Status: Y N U **Area Walk-By Checklist (AWC)**Location: Bldg. DIESEL Floor El. 130 Room, Area¹ SWITCHGEAR ROOM 2F**Instructions for Completing Checklist**

Status: Y N U **Area Walk-By Checklist (AWC)**Location: Bldg. REACTOR Floor El. 87 Room, Area¹ Unit 2 HPCI Room**Instructions for Completing Checklist**

Figure 1 – Surface Oxidation on 2E41-C002-2 Anchors (Unit 2 HPCI Room)

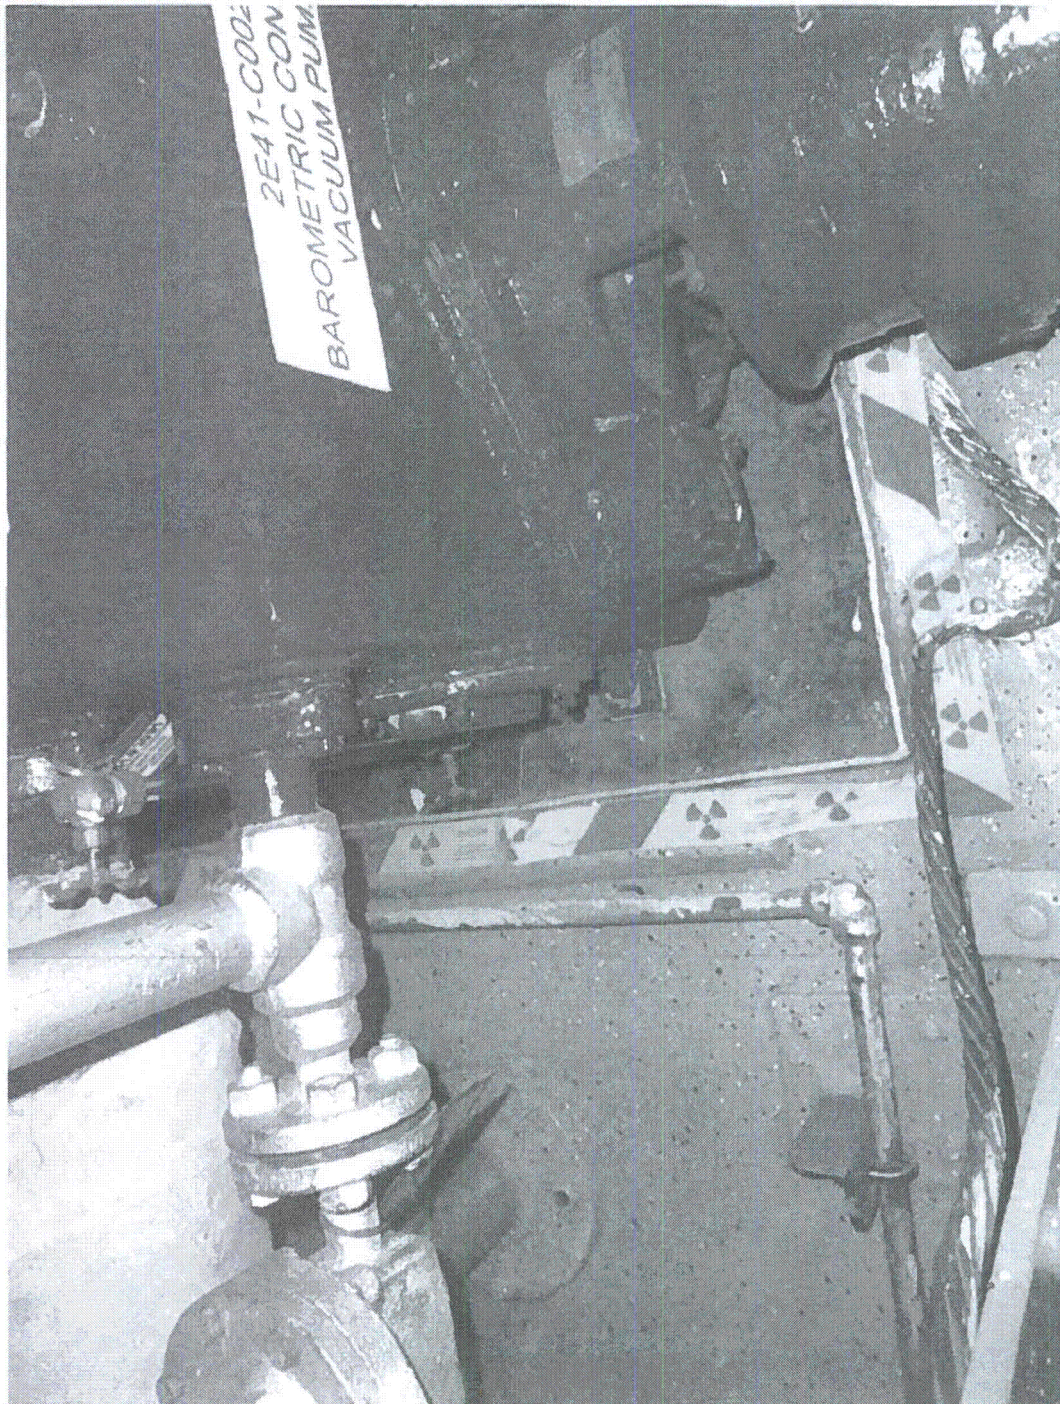
1. Does anchorage of equipment in the area appear to be free of potentially adverse seismic conditions (if visible without necessarily opening cabinets)? Y N U N/A
Mild surface oxidation present on anchors for 2E41-C002-2. Since oxidation is only on the surface, the anchors are not degraded. Therefore, judged to not be a concern.
2. Does anchorage of equipment in the area appear to be free of significant degraded conditions? Y N U N/A
3. Based on a visual inspection from the floor, do the cable/conduit raceways and HVAC ducting appear to be free of potentially adverse seismic conditions (e.g., condition of supports is adequate and fill conditions of cable trays appear to be inside acceptable limits)? Y N U N/A
4. Does it appear that the area is free of potentially adverse seismic spatial interactions with other equipment in the area (e.g., ceiling tiles and lighting)? Y N U N/A

Figure 1 – Pipe Clamp Missing Bolt (SE Diagonal Unit 2)

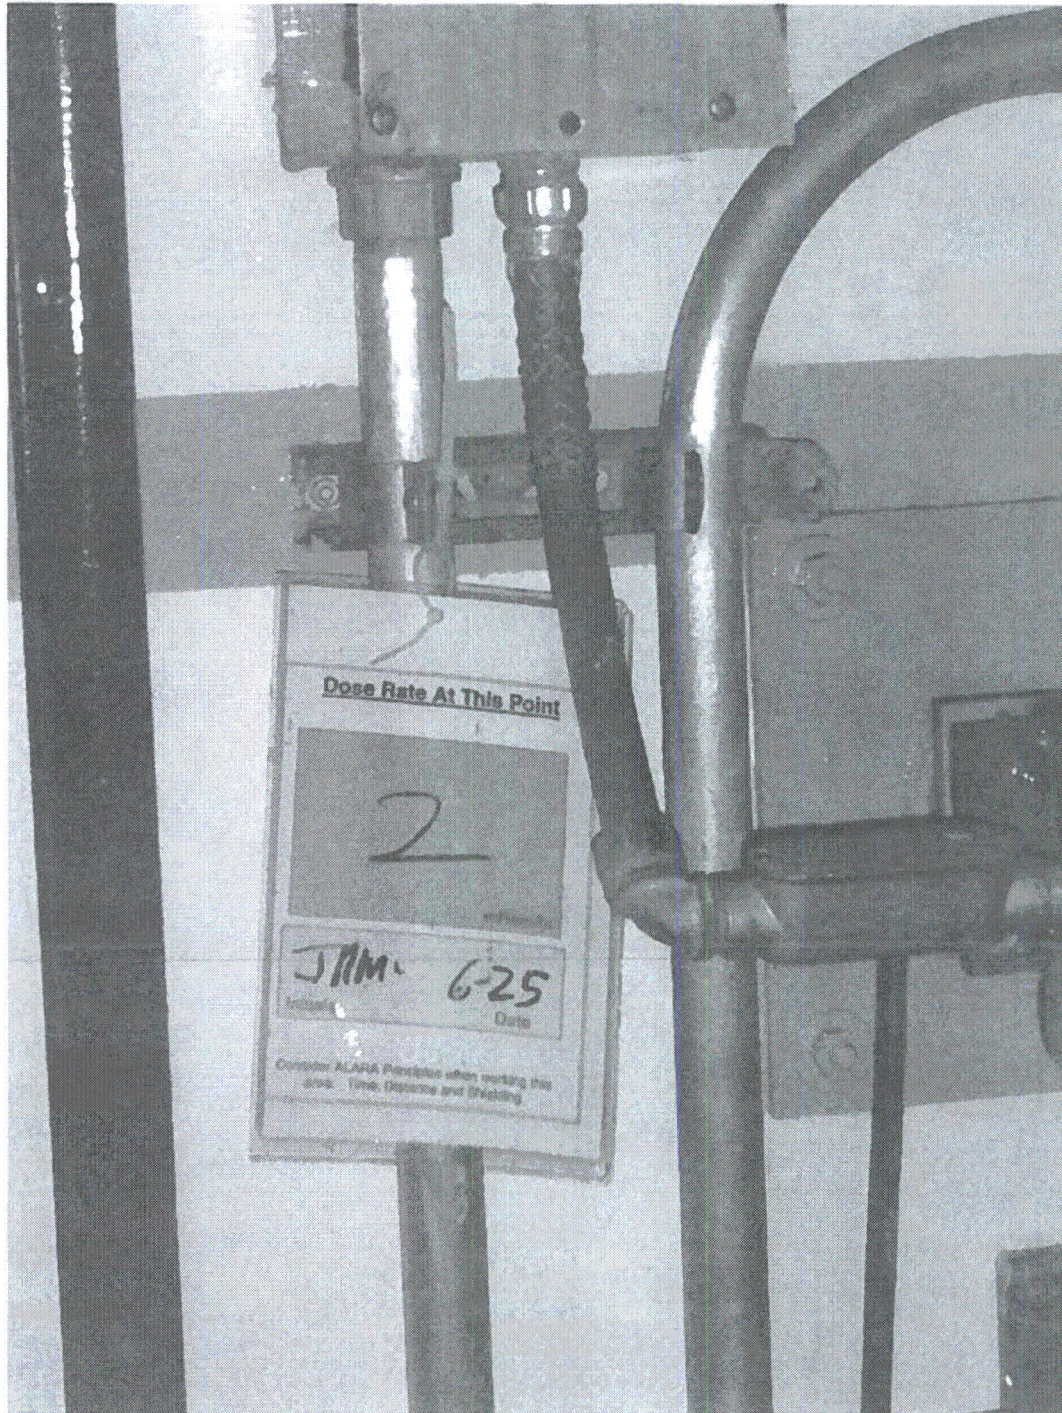
1. Does anchorage of equipment in the area appear to be free of potentially adverse seismic conditions (if visible without necessarily opening cabinets)? Y N U N/A
There is a Unistrut pipe clamp on the west wall missing a bolt. The pipe clamp is spread open, offering no restraint to the supported pipe (CR 515734). There are intact pipe clamps above and below the open clamp, so the unrestrained span of the conduit is small. The existing pipe clamps offer enough support to prevent significant movement during a seismic event.

Figure 2 – RHR Pump Bolt Oxidation (SE Diagonal Unit 2)

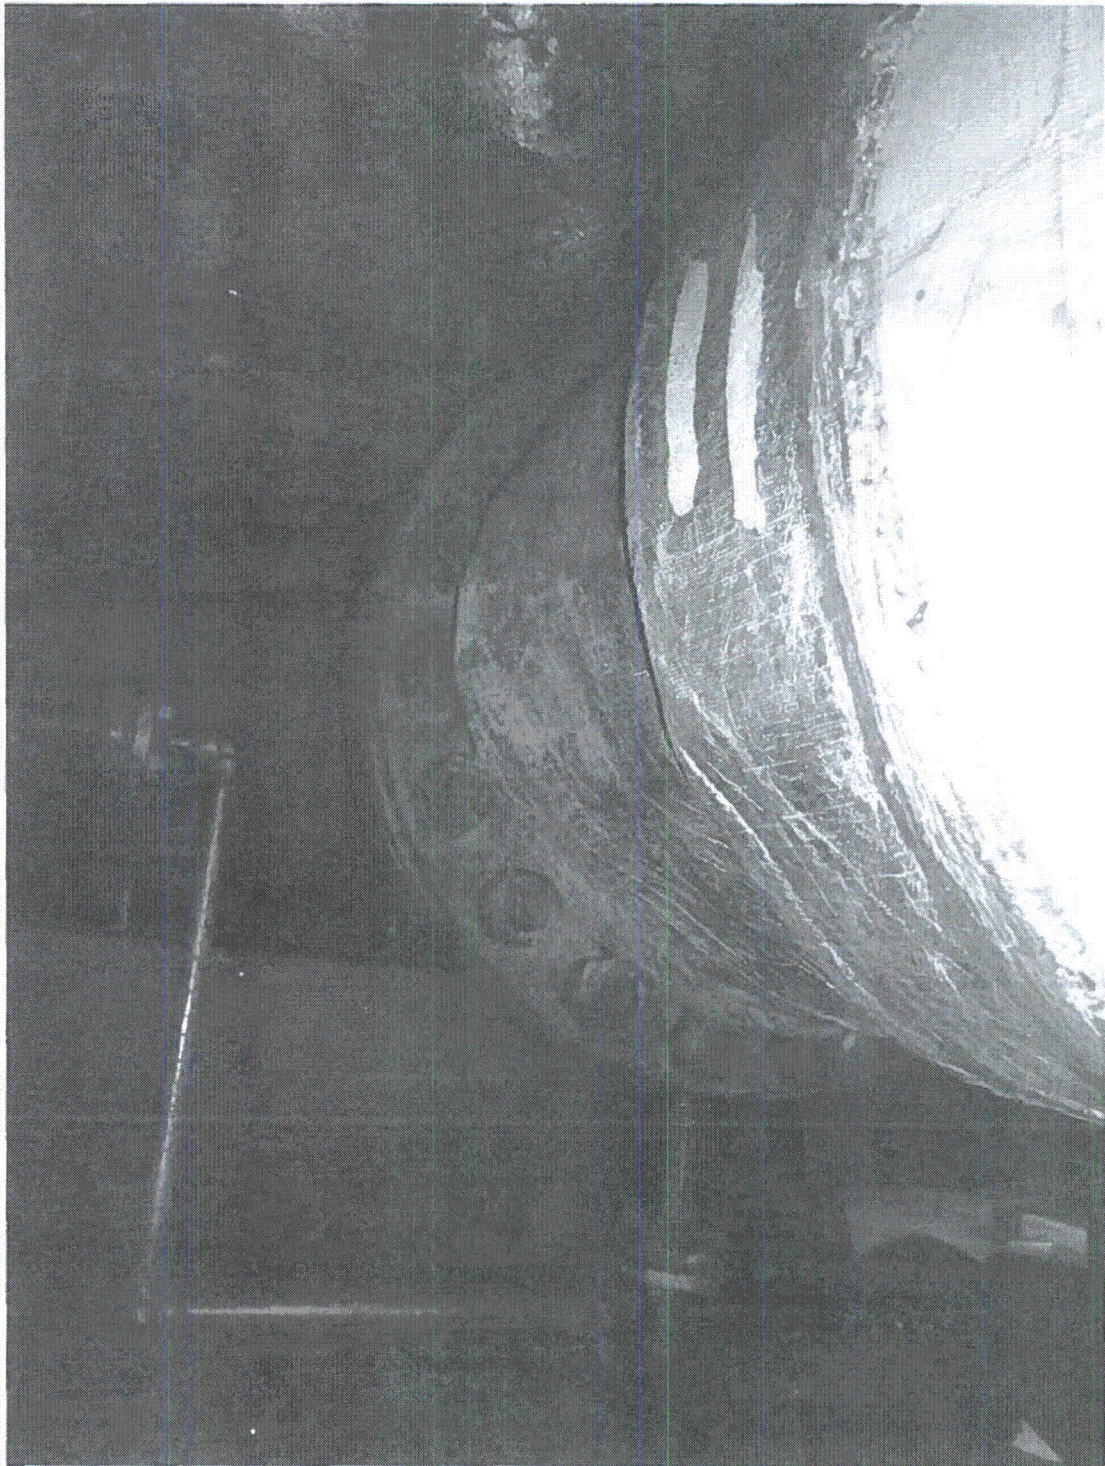
8. Have you looked for and found no other seismic conditions that could adversely affect the safety functions of the equipment in the area? Y N U
There is mild surface oxidation on the flange bolts for RHR Pump 2E11-C002D. Since oxidation is only on the surface, the bolts are not degraded. Therefore, judged to not be a concern.

Figure 3 – Loose Equipment Tag (SE Diagonal Unit 2)

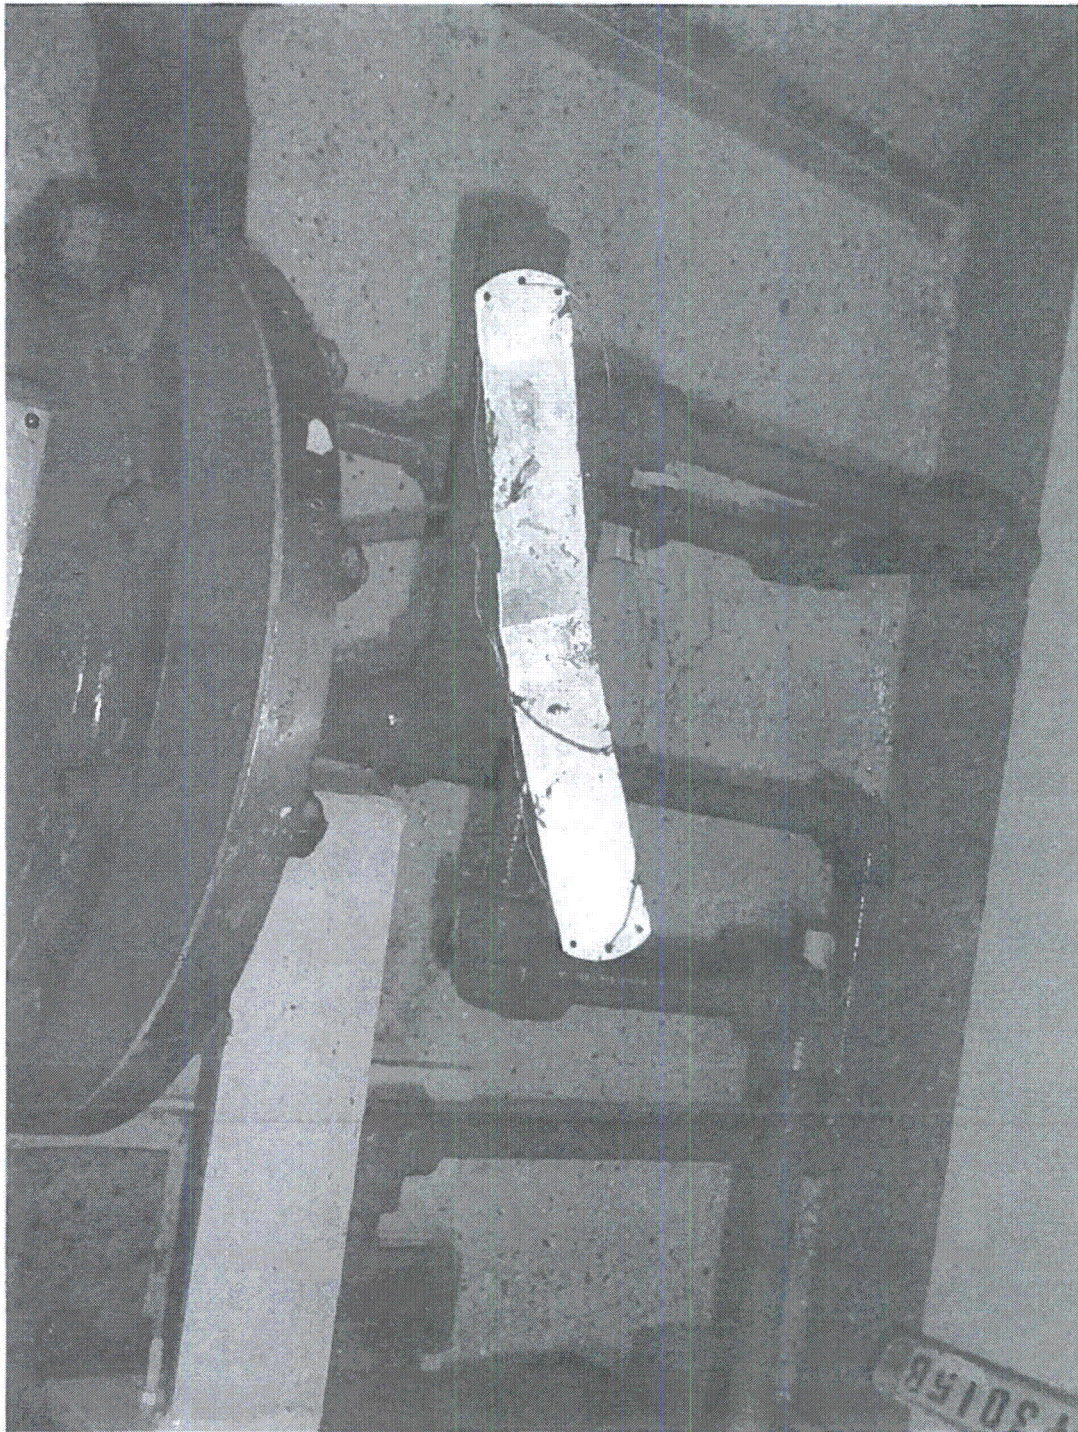
There is an equipment tag lying near Jockey Pump 2E21-C003B that is not attached to anything (CR 515736).

Figure 1: Items Stored on Hose Station

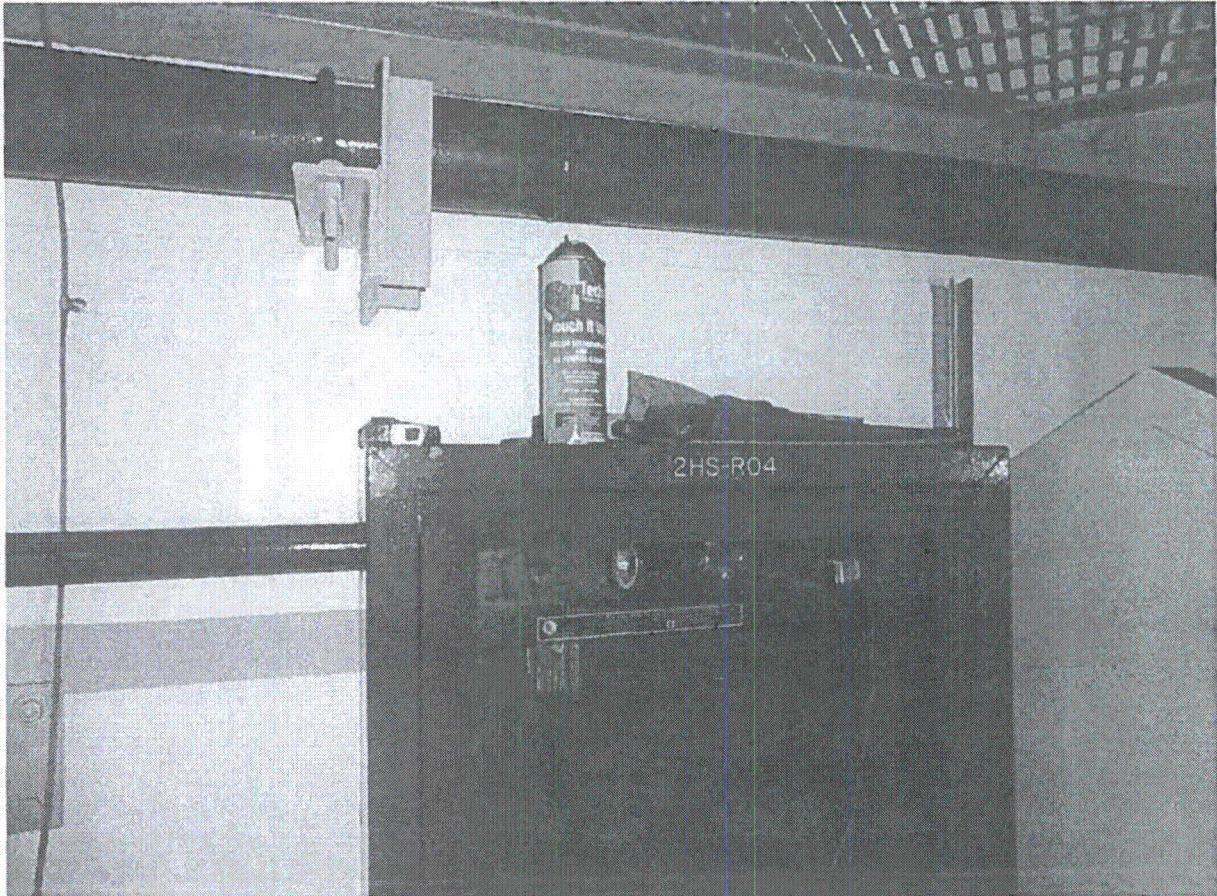
There are wrenches, a tape measure and cleaning supplies stored on top of Hose Station 2HS-R04. There are also poles stored on floor and a radwaste bag also stored on the floor near the Hose Station. SWE's have determined that these items are far from seismic/safety related equipment, therefore they are seismically acceptable.

Figure 1 – Missing Knee Brace Anchor Bolt (Unit 2 HPCI Room)

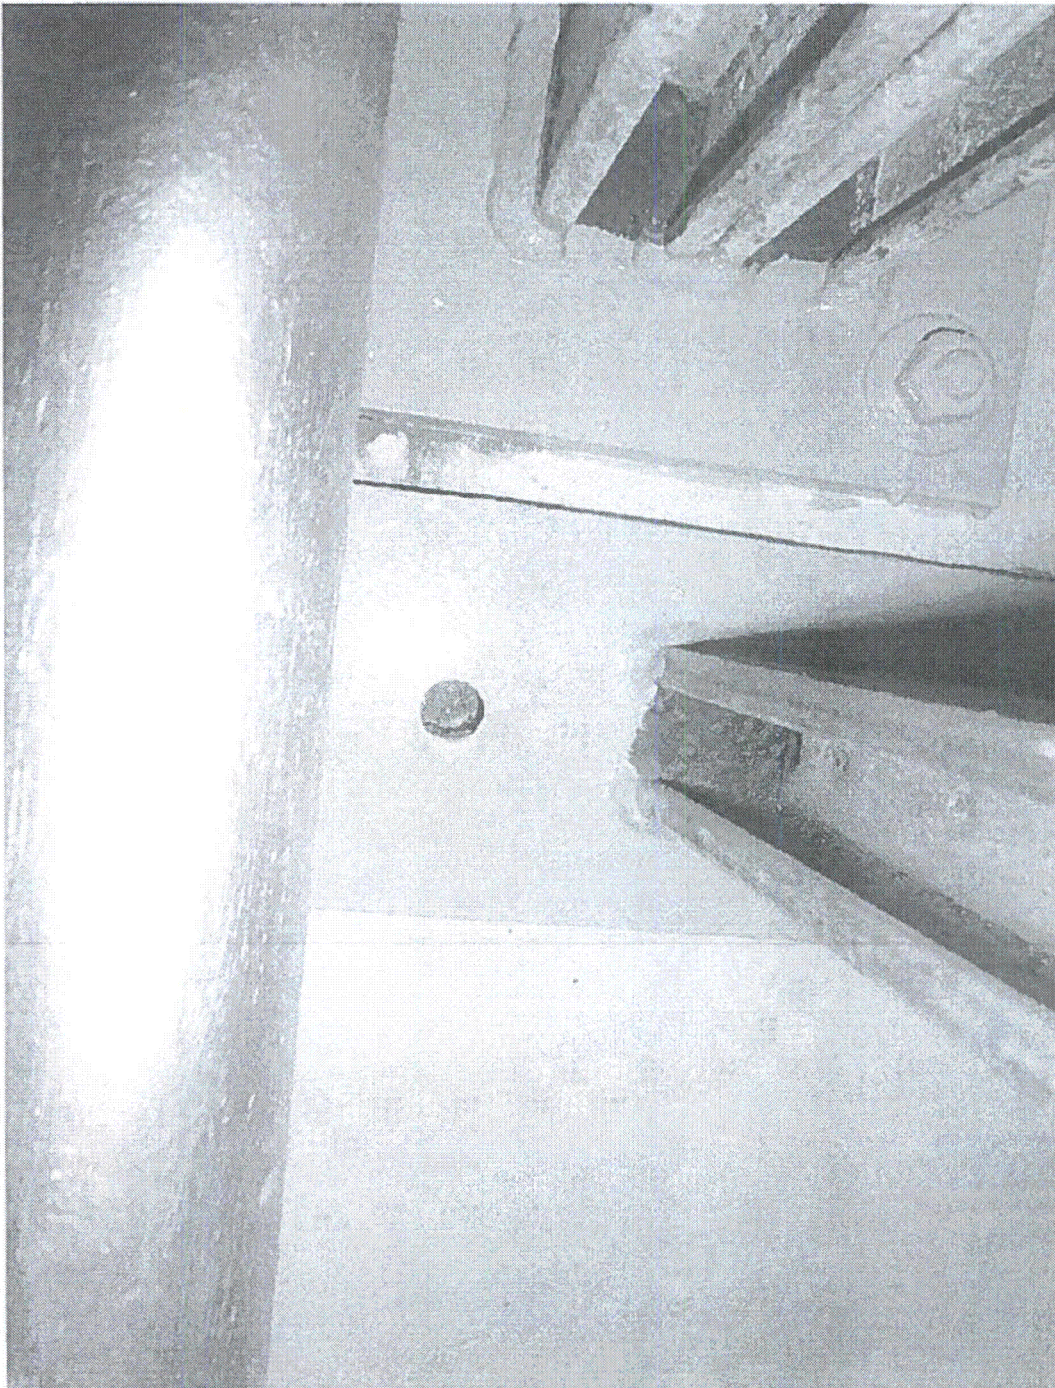
1. Does anchorage of equipment in the area appear to be free of potentially adverse seismic conditions (if visible without necessarily opening cabinets)? Y N U N/A
A knee-brace for conduit support near Valve 2E41-F007 near the 2T41-B005B HPCI cooler has only one anchor bolt (CR 515489). There is a hole in the base plate for the second bolt, but it appears that only one bolt was ever installed since there is no hole in the concrete. The knee-brace is one of a pair of supports for a small conduit near the wall. The second knee brace is fairly large and has all anchor bolts, so it is judged to have sufficient capacity to support the small conduit during a seismic event. This issue is addressed in CR 515489.

Figure 3 – Loose H01 Testing Lead (Unit 2 HPCI Room)

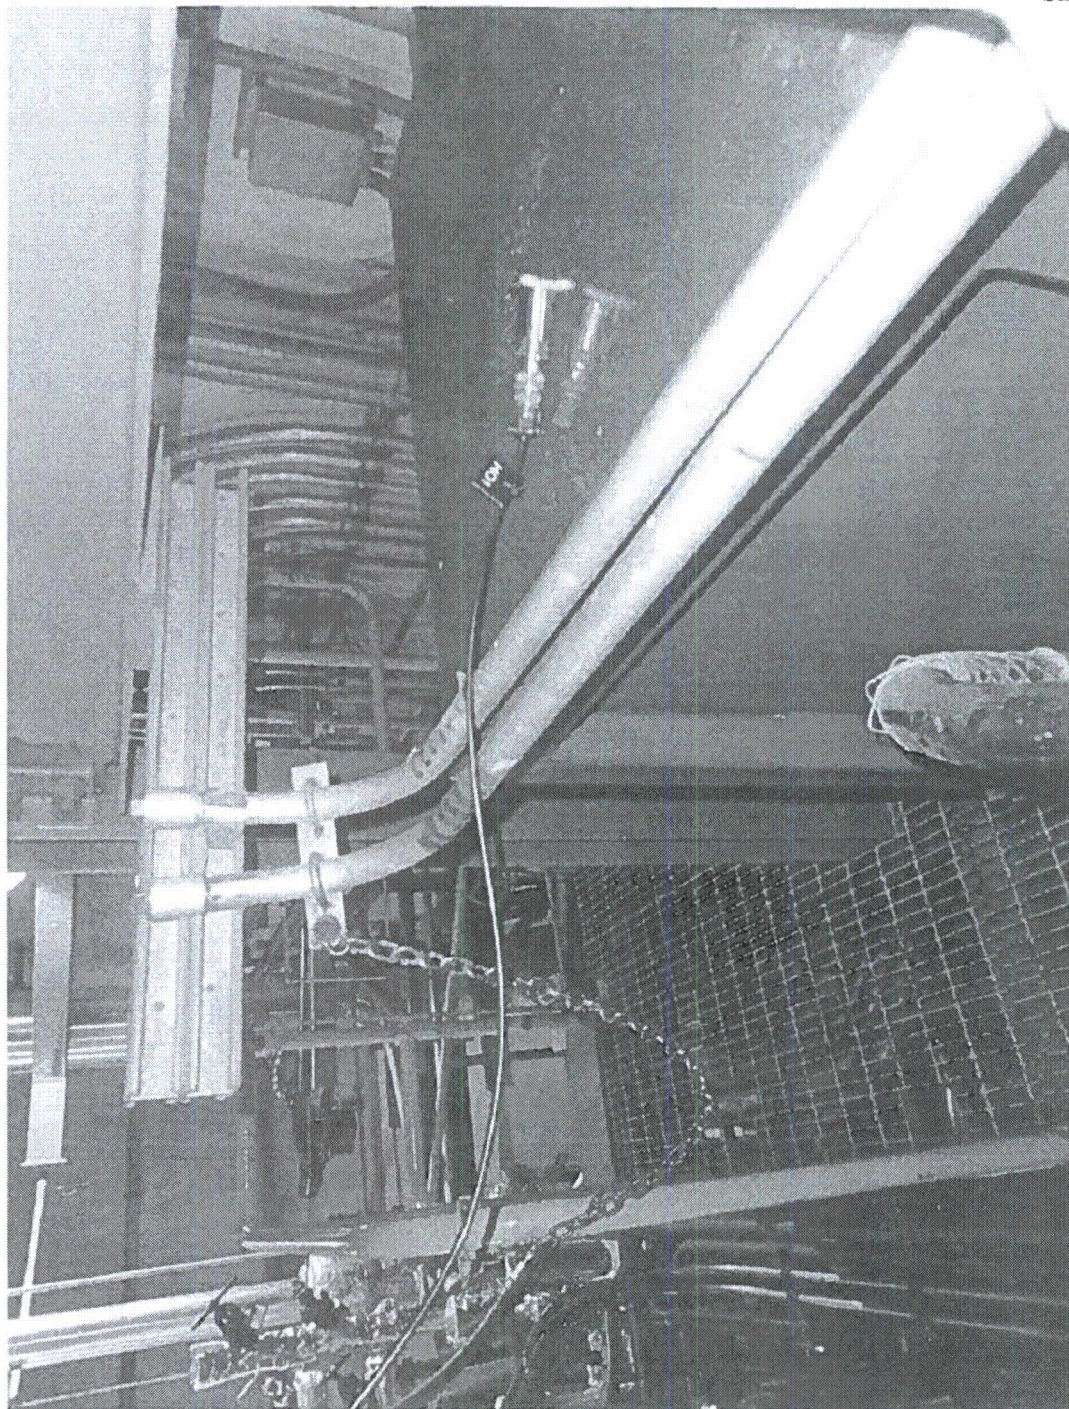
The H01 test connection lead was found lying on top of the 2T41-B005A cooler. The lead is very light and is attached by the connection cable to the body of the cooler. There is no delicate equipment in the vicinity of the lead, and the cooler is very rugged, so any impact will not be significant. Therefore, it is judged to not be a potentially adverse seismic condition. This item does not need to be moved.
